STAFF RECOMMENDATION
3910 Kimpalong Avenue
November 16, 2016

Application: New construction - infill
District: Woodlawn West Neighborhood Conservation Zoning Overlay
Council District: 23
Map and Parcel Number: 10316007300
Applicant: Vintage South Development
Project Lead: Paul Hoffman, paul.hoffman@nashville.gov

Description of Project: An application for new construction of a single-family residence with attached garage.

C 1.00

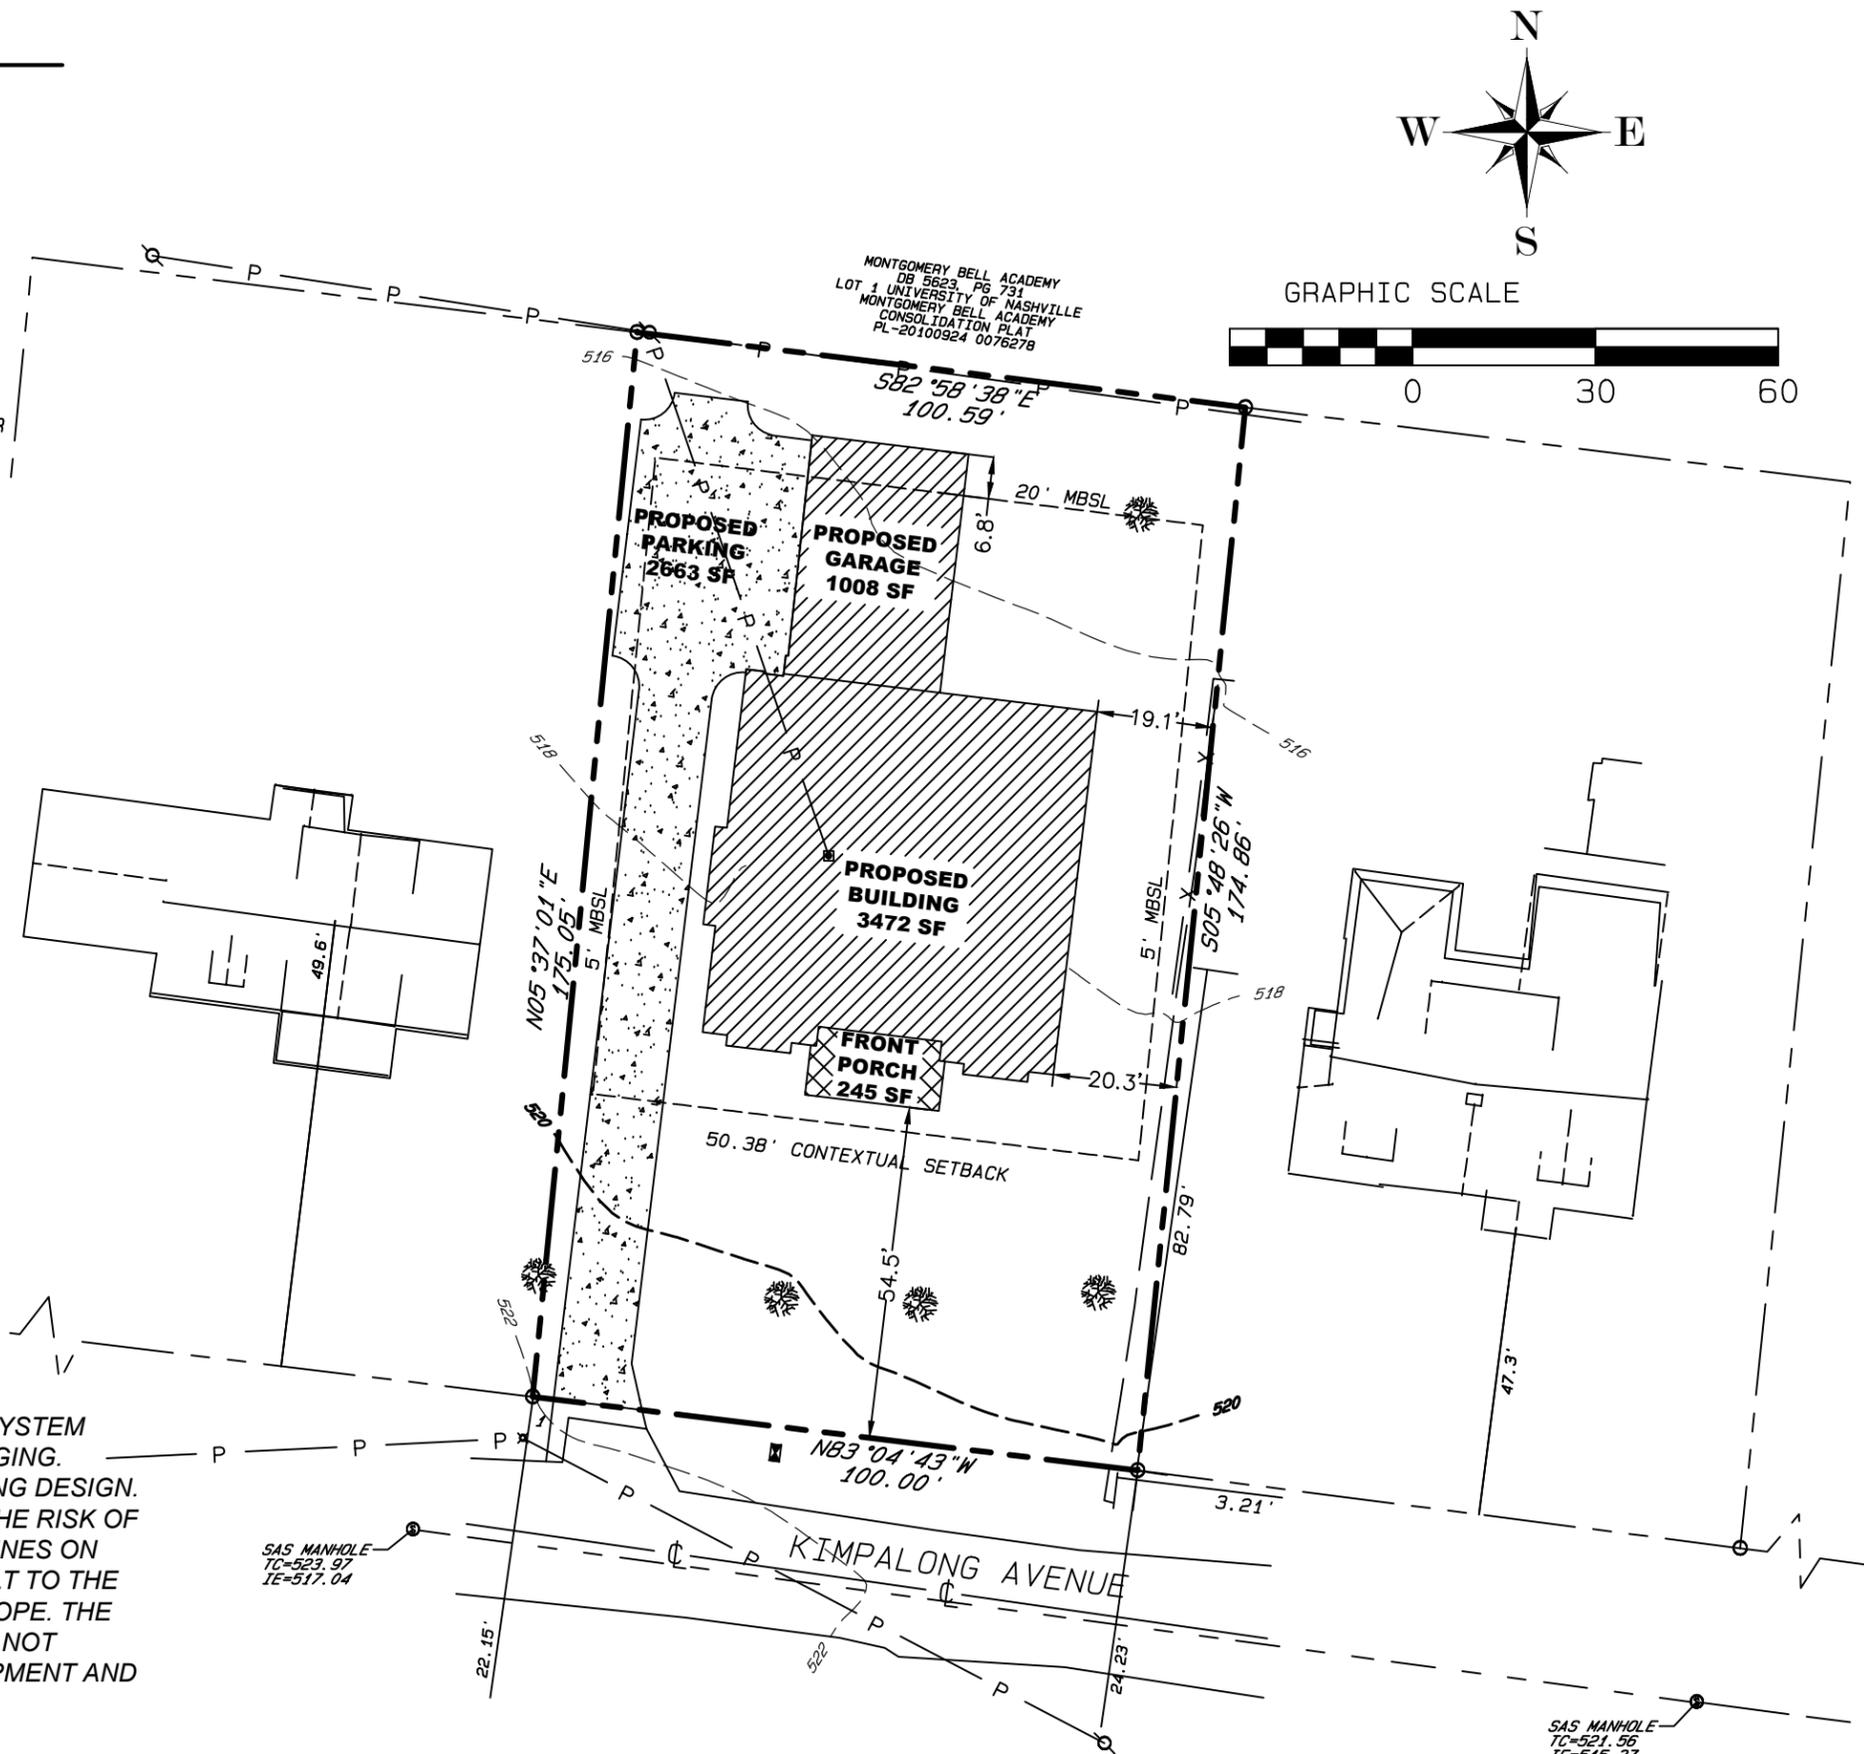
Front setback: The front walls of the contributing structures on this block are from forty-seven to fifty-two feet (47-52’) from the front property line. The site plan indicates the new building’s front porch at sixty-one feet (61’) from the front property line. Staff recommends the building be moved forward so that its front wall is in the established range.

Rear setback: The rear wall of the attached garage is proposed at thirteen feet (13’) from the rear property line. Base zoning requires a minimum of twenty feet (20’) rear setback. The rear setbacks of homes on the street range from fifty to seventy-three feet (50-73’). However those measurements are to the rear wall of the principal structure, not to an outbuilding. In 2013, MHZC approved the outbuilding at a neighboring property at twenty-two feet (22’). Because the rear wing is an attached garage and will be in the same location on the lot as adjacent outbuildings, Staff recommends the building be moved forward to meet the base zoning requirement of twenty feet (20’) of rear setback.

The site plan does not show a walkway to the street, which staff recommends, to meet the majority of the historic context. There is an existing driveway on the left side which will remain. Driveways are typical for this neighborhood because there is no rear alley.

The project will utilize an existing curb cut and left-side driveway. Staff recommends that the HVAC be located on the rear façade, or on a side façade beyond the midpoint of the house, to meet section II.B.1.i.

Moving the building forward will allow for both front and rear setback to meet base zoning and not require a setback determination. With this condition that the building is shifted forward on the lot, staff finds that the project will meet Section II.B.1.c for setback and rhythm of spacing.

A1-3

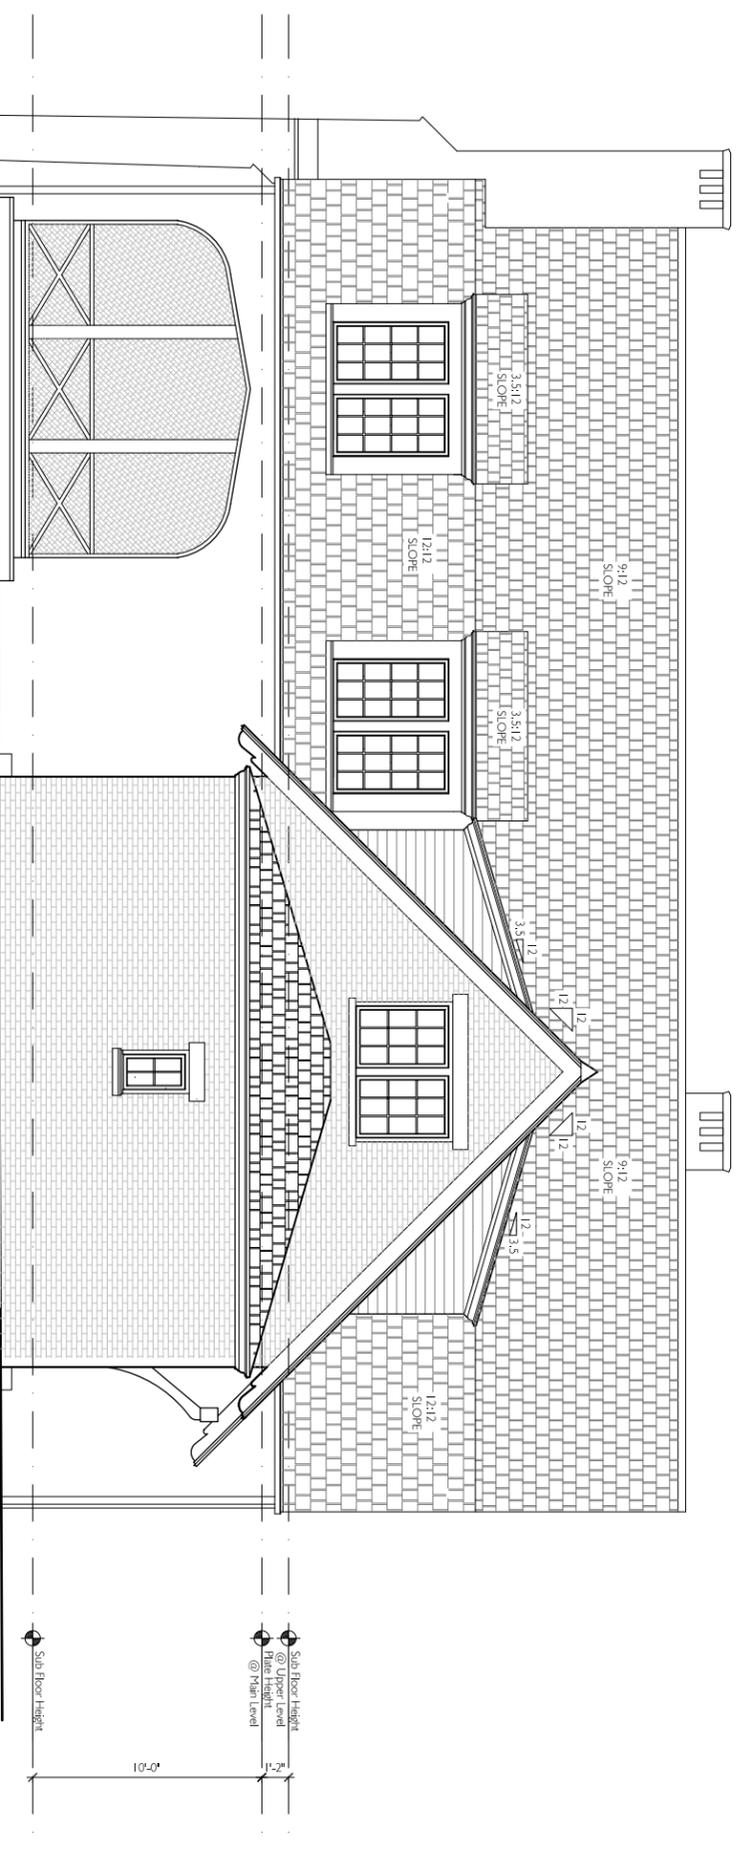
The proposed roof form includes hips, gables, shed dormers on the rear attached garage, and a shed roof over the front porch. Individually these roof forms are found in the district. The midsection of the building features a broken gable roof form, of which there is one example in the district, and has been approved by the Commission in the Richland-West End overlay, nearby. Although there is not an example on this street, Staff’s review is that it is compatible, does not contrast greatly with the roof forms of nearby structures, and will meet Section II.B.1.e.

A2-2

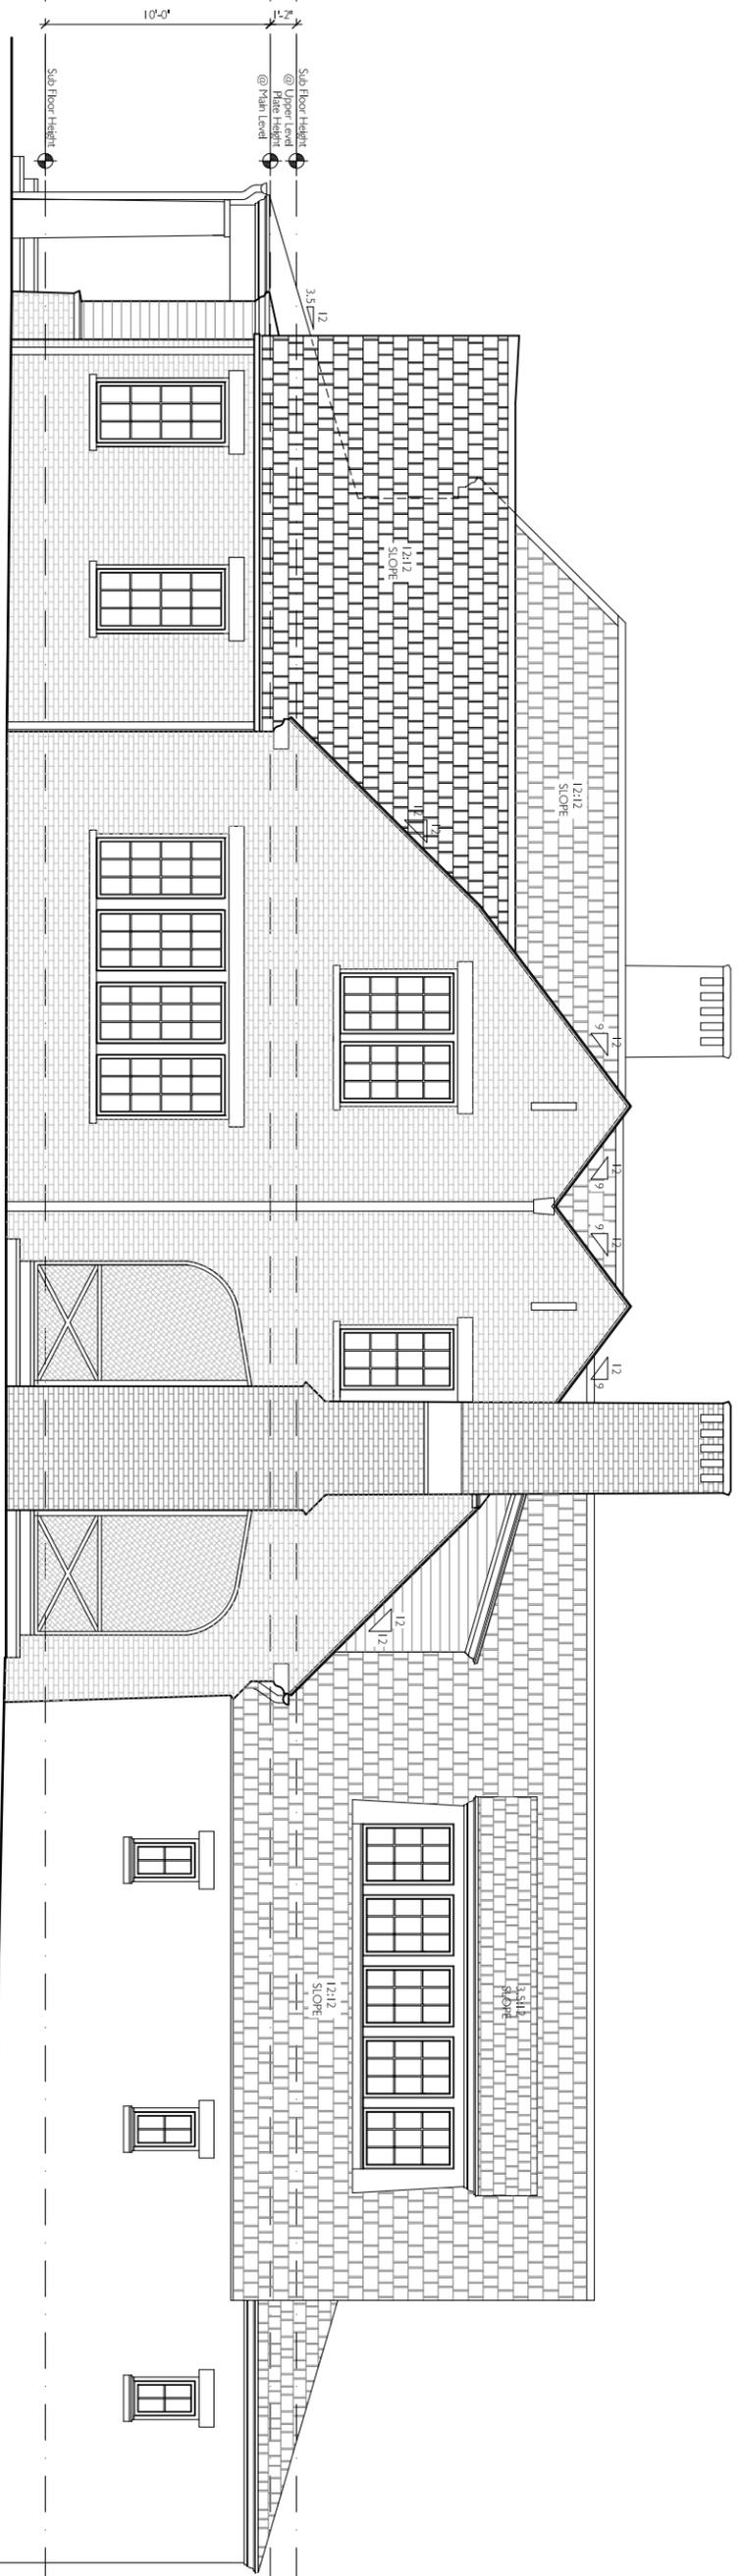
Height & Scale: The proposed building is a story and a half with a two-story portion at the midpoint. As designed there is no change in material at the floor level, as the brick cladding continues to the foundation. (See section on Materials)

The exterior wall material carries to the ground level. While it is most appropriate to have a change in material at the floor level, the Commission has approved a brick foundation when a soldier course or rowlock has been added. Therefore, Staff recommends the foundation be differentiated from the wall material with either a material change or a change in the brick pattern. With this condition, and the condition that Staff approve windows, doors, roofing color, masonry, and other materials that have not been specified, the materials are compatible and meet Section II.B.1.d.
